2.0 SITE CHARACTERISTICS

This chapter of the Fermi 3 Combined Operating License (COL) Final Safety Analysis Report (FSAR) addresses the geological, seismological, hydrological, and meteorological characteristics of the site and vicinity, in conjunction with present and projected population distribution and land use, and site activities and controls.

2.0.2 Summary of Application

Figure 2.4.5-2. STWAVE Data Points Near Fermi 3

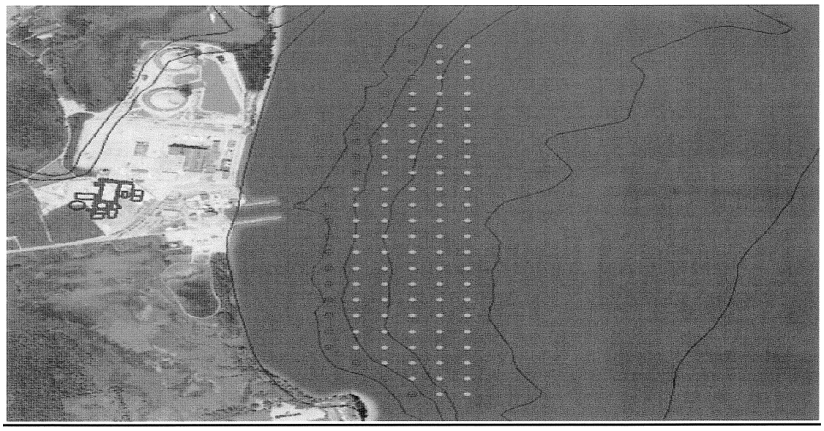
The STWAVE data points near the Fermi 3 are shown in Figure 2.4.5-2. The wave periods at all these points are 11.1 seconds. The wave height at the point near Fermi 3 is 3.7 m. The

wave parameters selected by the applicant using STWAVE are conservative based on the staff's independent verification using additional data received in RAI responses. These parameters, including wave period and distribution of wave height, were used for further calculation of wave action across the shore.

Figure 2.5.1-5 Photographs of Strata in the Denniston Quarry, Monroe, Michigan.

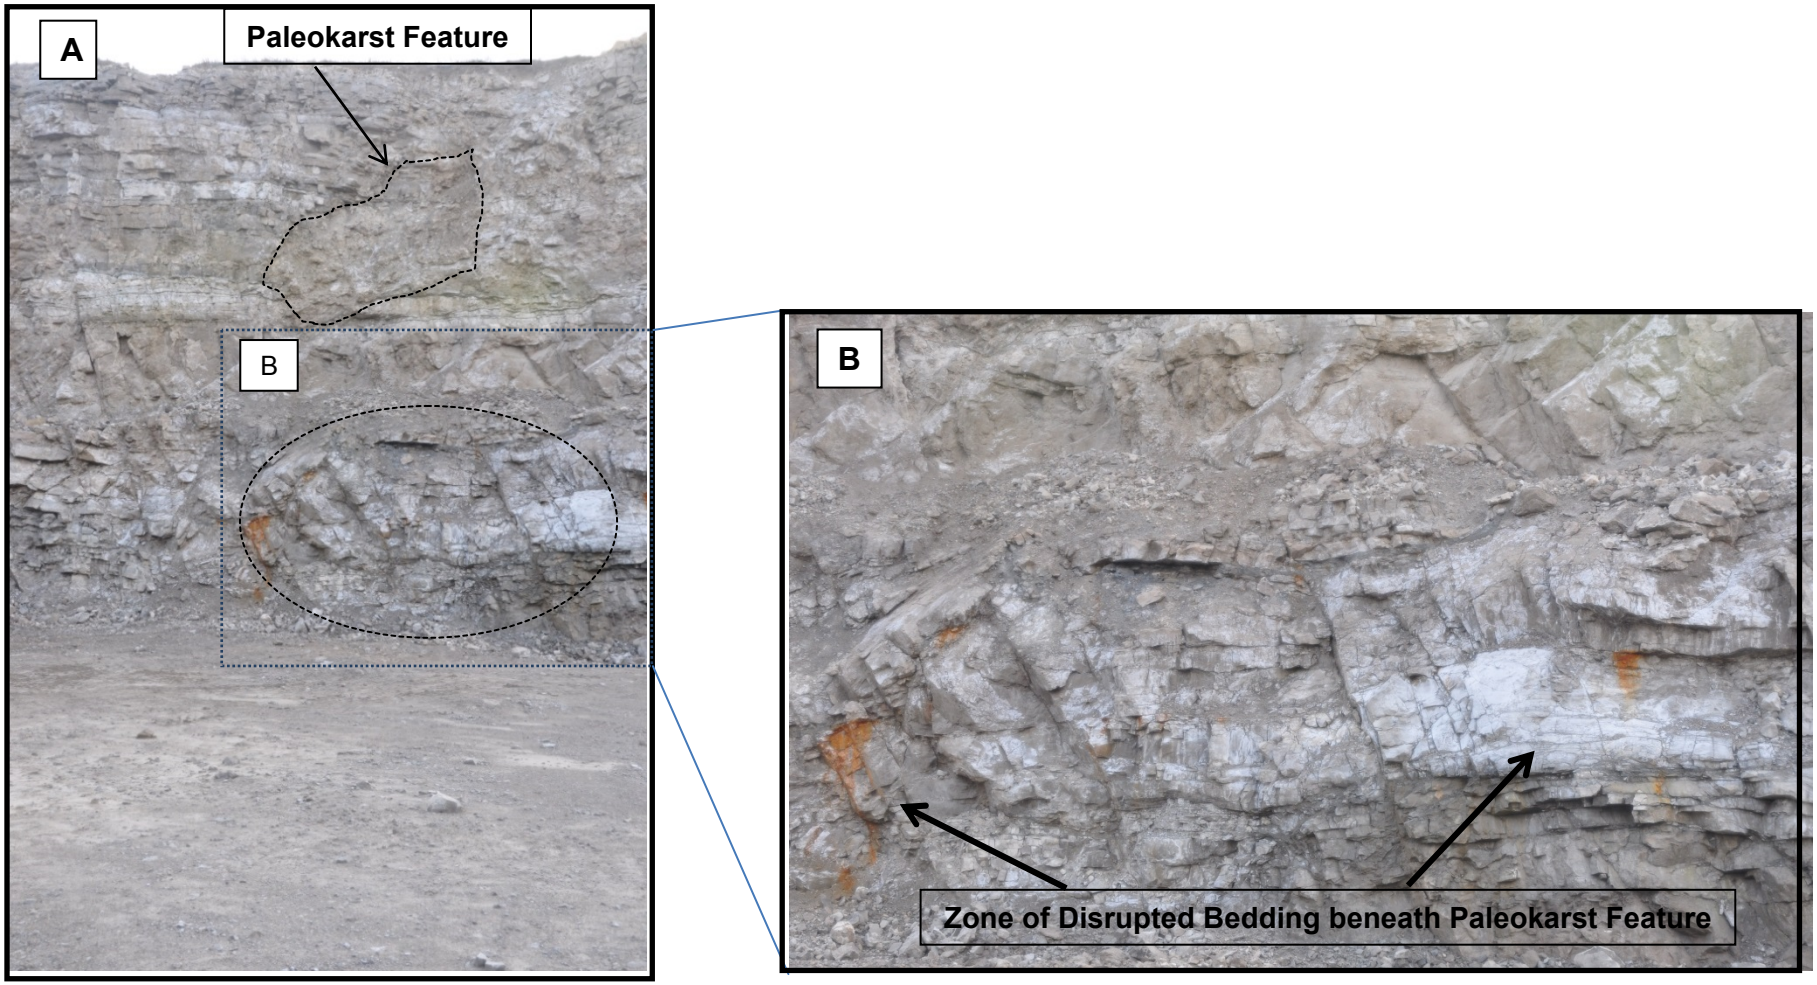
During the NRC staff's visit to the Denniston Quarry in Monroe County, Michigan, as part of a November 2009 Fermi 3 COL site audit, the staff noted at least three zones of disrupted bedding exposed in the quarry walls. These disrupted zones suggest possible faulting of the Bass Islands Group. In one location, disrupted bedding exists beneath an interpreted paleokarst feature (located near the top of the geologic section) and suggests that the paleokarst development may be associated with faulting at depth. Figure 2.5.1-5 in this SER shows this paleokarst feature above a zone of disrupted bedding in the Bass Islands Group. In a second quarry location, a zone of disrupted bedding exists with mostly undisturbed bedding on either side. This second zone appears to be at least seven to ten meters wide; contains disrupted bedding from the top to the bottom of the exposed wall; and is flanked by relatively undisturbed bedding on both sides. The third zone of possible disturbed bedding was visible in a distant wall and could be related to vertical offsets within the Bass Islands Group.
